# **Lucas Heights Resource Recovery Park Project Response to Submissions and Preferred Project Report**

PART 1 - Main Report

June 2016

Figure 5 March 2014 surface gas emissions

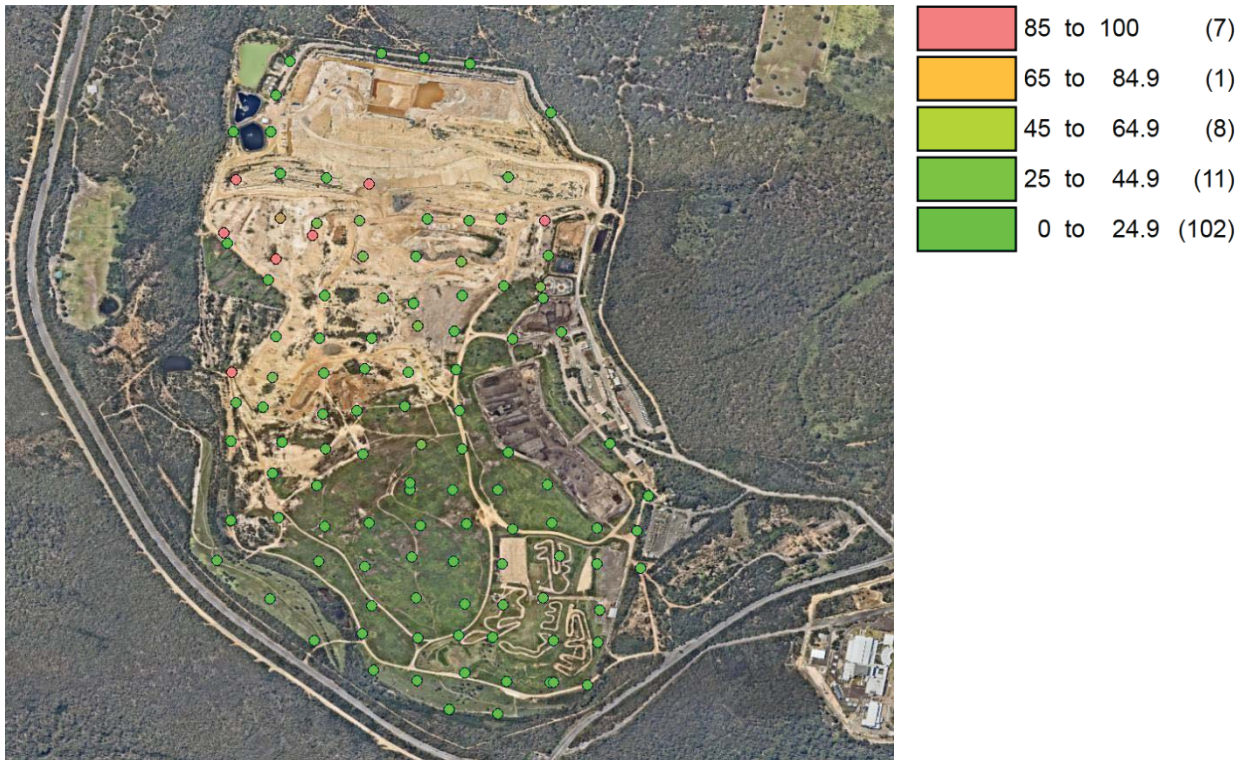
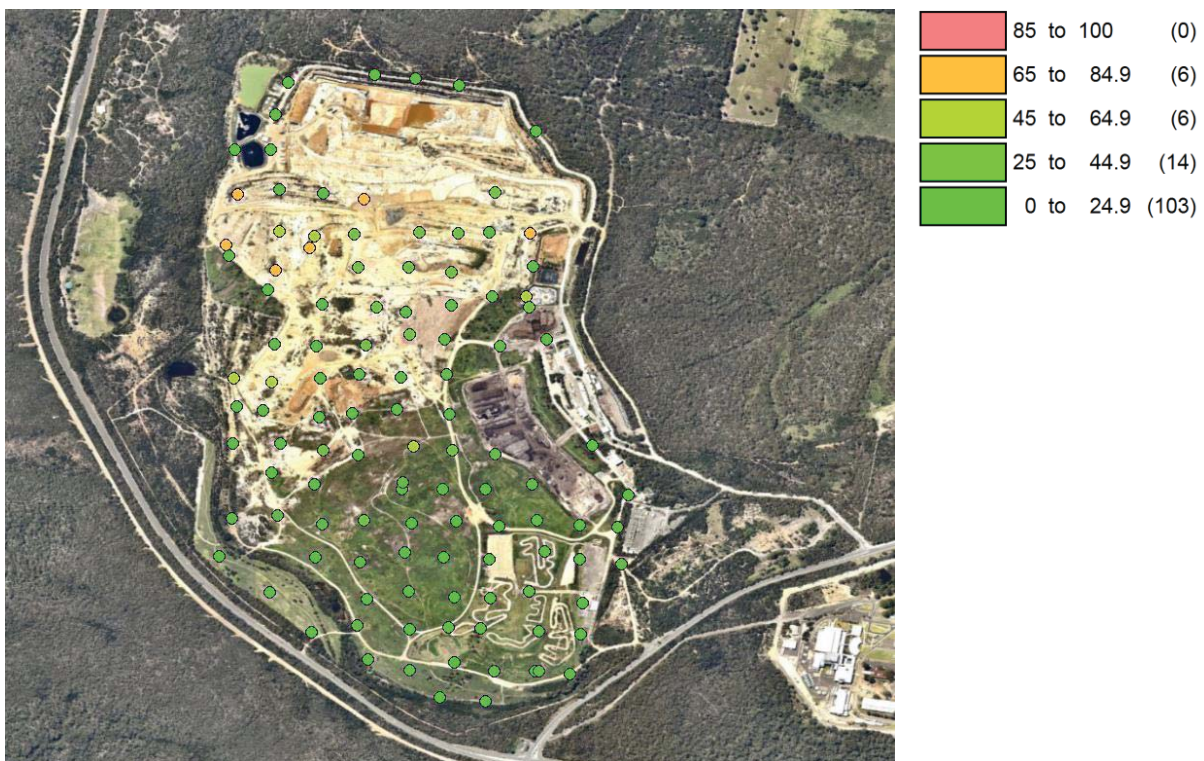
SUEZ undertakes quarterly landfill gas surface emission monitoring at the LHRRP. Since rectification works occurred in June / July 2014, review of the landfill gas surface emission monitoring data confirms improvement in the "v section" and "rectangular area south of the excavation stockpile". Figure 5 – Figure 8 below are prepared which shows decrease in emissions before (March 2014 plots) and after rectification works (July 2014, October 2014 and December 2014 plots).

- Landfill gas surface emissions at the LHRRP are all below 100 ppm during March, July, October and December 2014
- Data shows a step change improvement - landfill gas surface emissions dropped by approximately 10 ppm across the identified problem areas between March 2014 (pre-rectification) to July 2014 (post-rectification)
- The reduced landfill gas surface emissions maintained over the rest of the year as validated by the October 2014 and December 2014 figures
- Number of locations where with surface gas emissions higher than 85 ppm reduced from 7 locations in March to 0 locations in July, and 1 in October, and 0 in December 2014
- Based on the above, it could be demonstrated that rectification works links with sustained reduced landfill gas surface emissions at the LHRRP which correlates with reduced potential odour emissions from the site

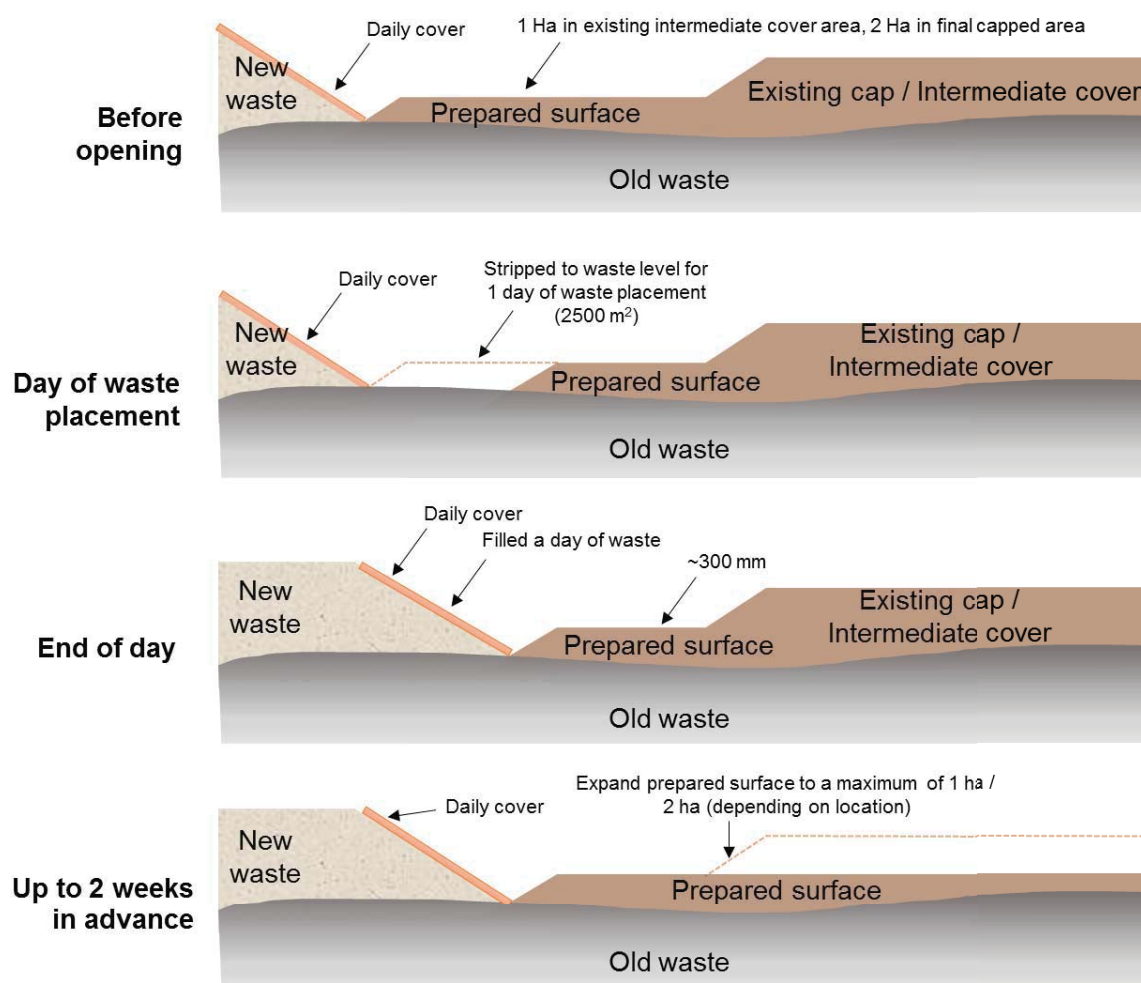
- a) The EPA requests further detail on why 2,500 m<sup>2</sup> was used to predict odour impacts from the “stripped back areas” in odour modelling scenarios 2, 3 and 4 but up to 2 hectares of stripped back area proposed in the EIS?
- b) The EPA requests an additional odour modelling scenario be done using the stripped back areas proposed in this EIS.

- a) The Figure below shows a summary of the proposed strip back mechanism

Figure 10 Updated Garden Organics concept layout

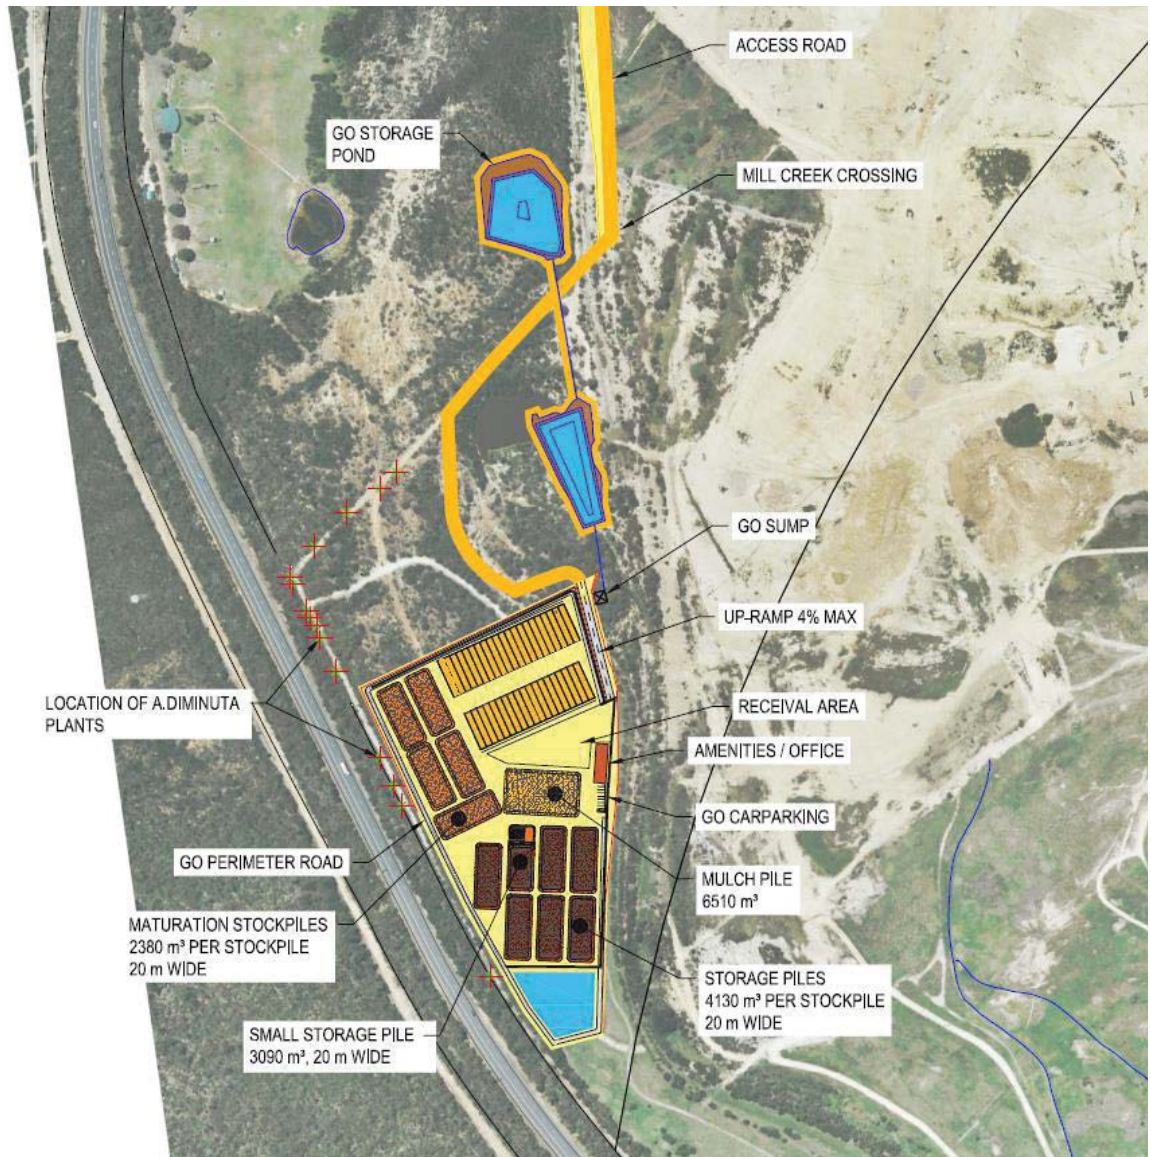
In response to OEH response to the EIS, adjustments have been made to the GO facility design since the submission of the EIS to DP&E to minimise impacts on the endangered population of *Allocasuarina diminuta* subsp. *mimica*. A survey was conducted in the company of a qualified surveyor in March 2016 to accurately map the location of the ramets with respect to the layout of the GO and ARRT facilities, and to refine the layout of these facilities in order to minimise impacts on the endangered population. Due to redesign of the GO facility, no *Allocasuarina diminuta* subsp. *mimica* ramets are present with the GO facility footprint.

The redesign of the GO facility has also allowed a reduction in the size of the pond that was located to the north of the ARRT facility. This is now set back further from the nearby Coastal Upland Swamp EEC, further minimising the potential for indirect impacts on this community.

The requested information is provided in Figure 10 below.

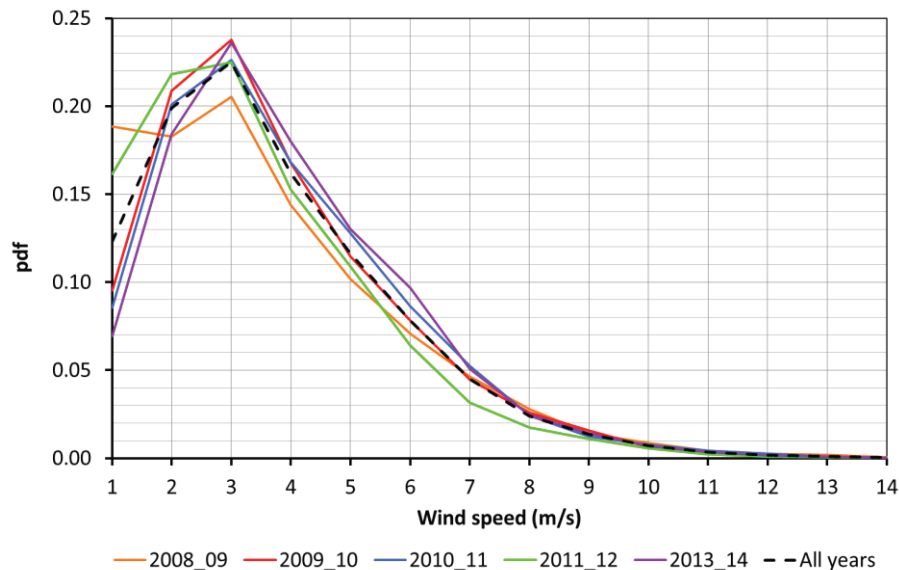
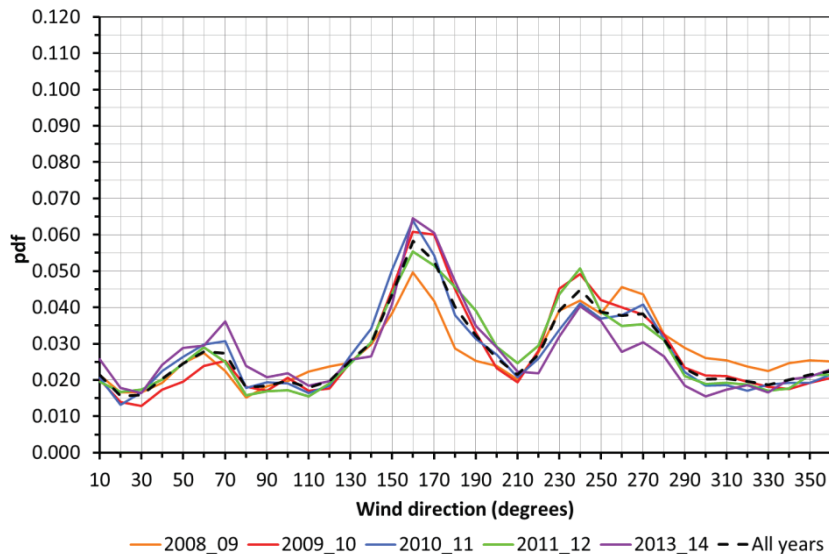
The on-site data has had a meteorological examination of the 15 minute averaged data across the available five year period.

For the key parameter, in dispersion meteorology of ground based odour sources, of wind speed distribution it is found that the selected year of 2011-12 is 'representative'.

The 2011-12 Probability Distribution function (PDF) is within the yearly range for all years and there are no significant deviations from the 'All-years' average.

**Figure 111 Example design of membrane cover (GORE and associates, 2013)**

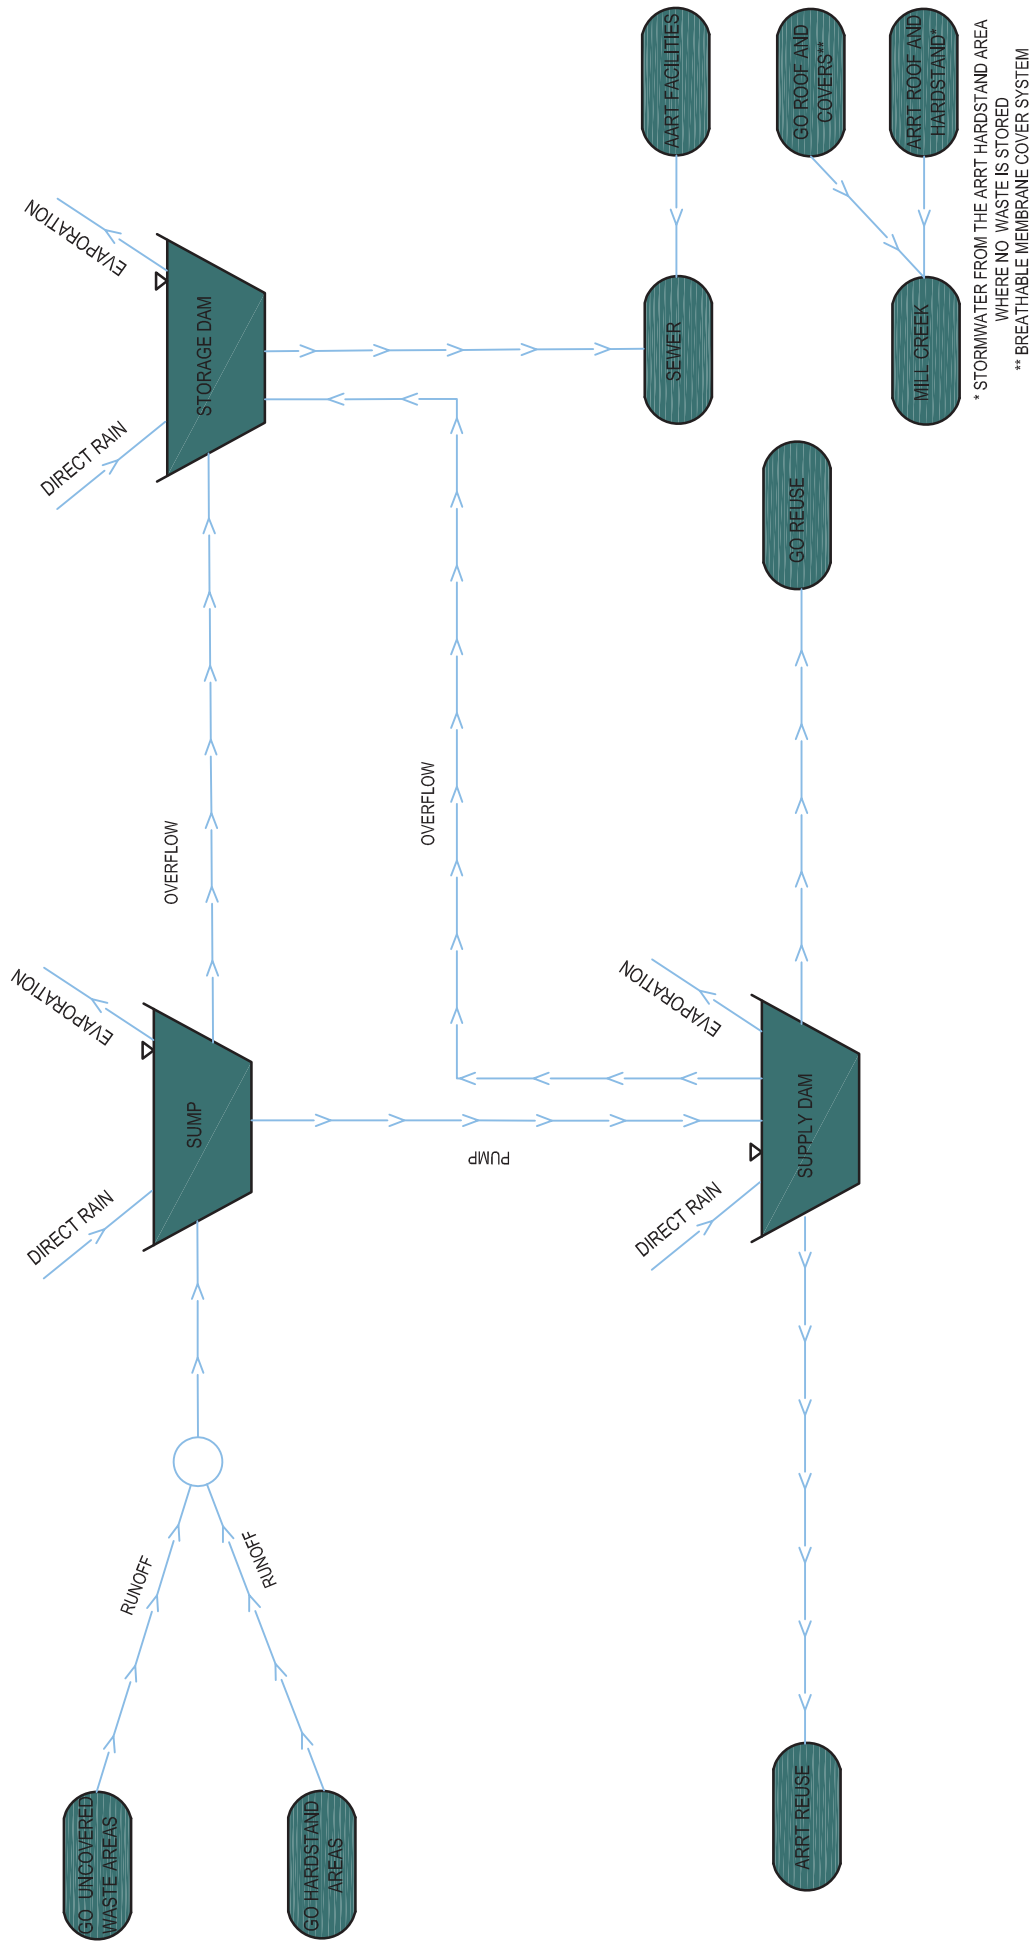
Design and operation of a breathable cover system which could shed uncontaminated stormwater is possible. An example of one design developed by GORE (GORE and associates, 2013) is shown in Figure 11 below and further designs are available (refer reference).

It is recommended that the EPA consider conditioning this issue to require at the EPL application stage the detailed design which demonstrates that uncontaminated stormwater would be shed from the breathable covers.

Figure 12 LHRRP tradewaste discharge volumes April 2014 – Jan 2015

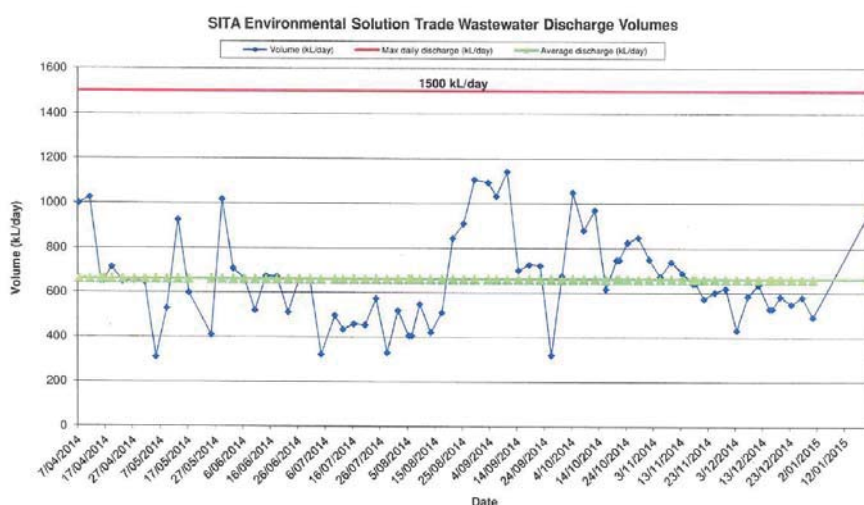
The EPA notes that the proposal is planned to commence in June 2015.

Figure 12 and Figure 13 shows discharge volumes from the LHRRP between April 2014 to October 2015. The current Trade Waste Agreement (TWA) allows a maximum discharge of 1500 kilolitres total discharge with an average daily discharge limit of 800 kilolitres. As shown in figure below, the average discharge in 2014 was just over 600 kL/day and approximately 800 kL/day in 2015. SUEZ is below our allowable limits hence the processing requests with Sydney Water is not expected to be a problem

**Figure 5.2 Proposed dual gas/leachate trench typical arrangement**

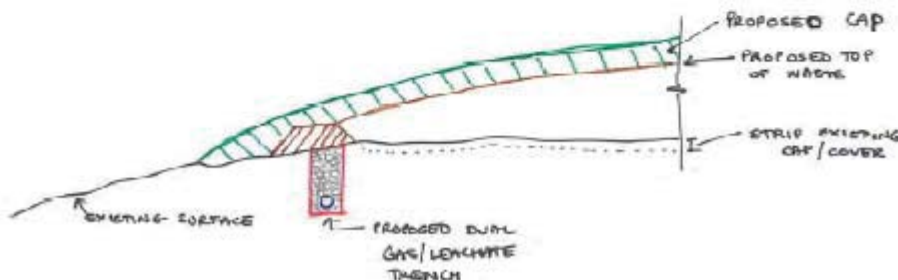
To intercept any sideways movement of leachate and providing additional extraction points, a dual gas/leachate management trench would be constructed near the perimeter of the re-profiling area. Sections of trench would be constructed as landfilling progresses.

The purpose designed trench would consist of a nominally 1.5 – 2 m deep trench within the existing waste mass backfilled with site-generated crushed sandstone and perforated pipe. The typical arrangement for the trench is illustrated in Figure 5.2. This trench would act as an extraction point for any sideways movement of leachate, should it occur. Extraction risers would be located along the length of the trench, to allow leachate to be extracted and transferred to the existing leachate ring main. Detailed design of the system would be undertaken prior to installation and would include consideration of the predicted leachate flows, settlement and strength requirements. A construction environmental management plan would be required to manage potential impacts to surface water during the installation of the system.

Figure 14 Revised storage dam arrangement for the GO facility

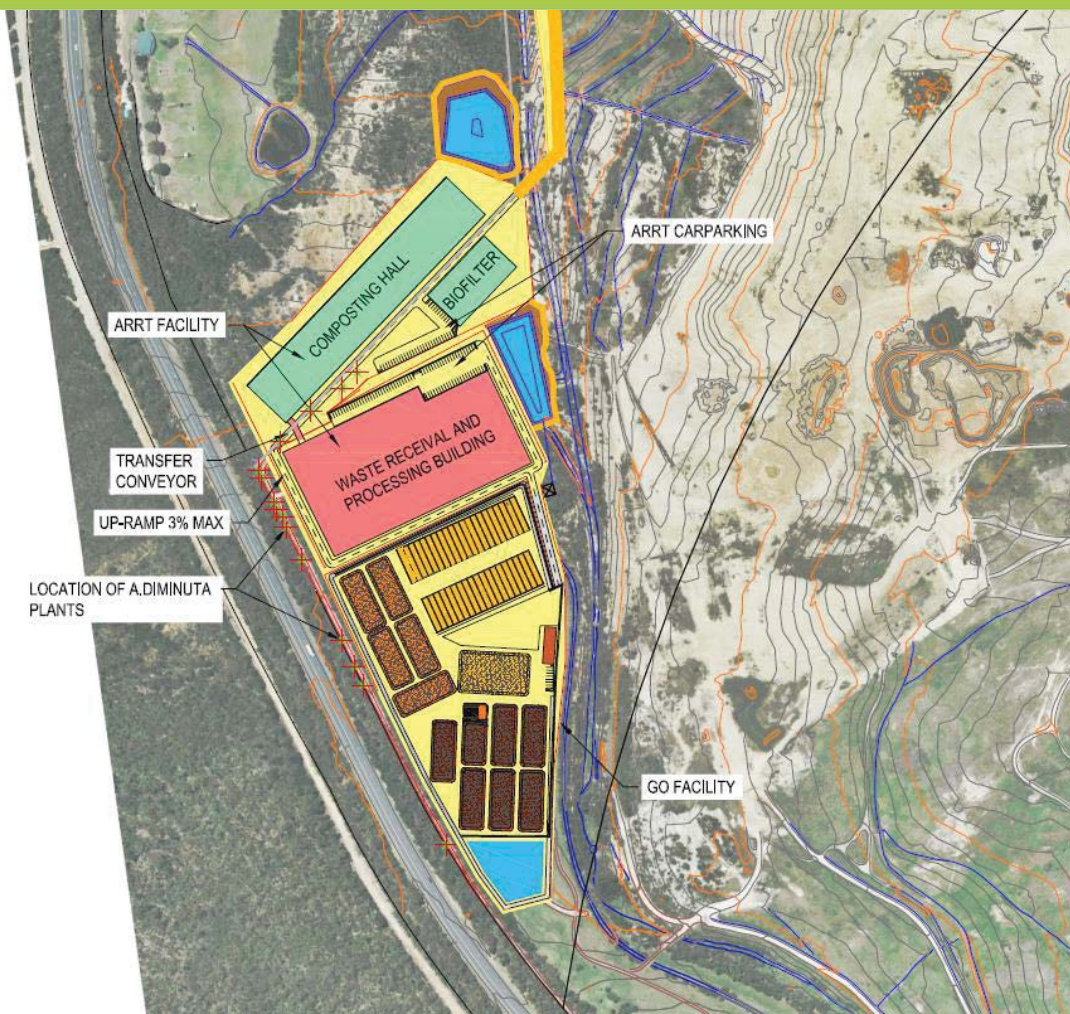
In consideration of the comments provided by the DPI and OEH, a review was undertaken regarding the location and size of the storage dams. The size of the northern storage dam was reduced by proposing an additional storage dam east of the proposed ARRT facility. The creation of this dam also allowed reduction of the footprint of the southern storage dam. The updated concept dam arrangement is shown in Figure 14 below.

In consideration of the comments provided by the DPI and OEH, a review was undertaken regarding the location and size of the storage dams. The size of the northern storage dam was reduced by proposing an additional storage dam east of the proposed ARRT facility. This increases the distance between the Coastal Upland Swamp and the proposed storage dam. The updated concept dam arrangement is shown in Figure 14 above.
